Upper Shock Absorber Mounting Bracket

SAF-HOLLAND has revised the design of the upper shock absorber mounting bracket that is required for some low ride height variants of Modul suspension.

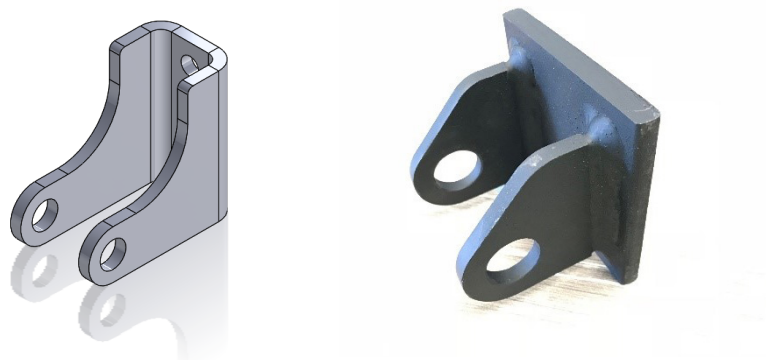
Up to now, a version of the upper shock bracket (shown below left) was supplied to the market. This part was locally-manufactured and sourced directly by SAF-HOLLAND Australia for Australia.

As a continuous improvement exercise, SAF-HOLLAND Australia has replaced that mounting bracket with an alternate version (shown below right).

The new version is designed to be welded directly to a cross-member or other suitable fixture on the trailer chassis. There will be no change to the part number, as the new part will simply supersede the old part.
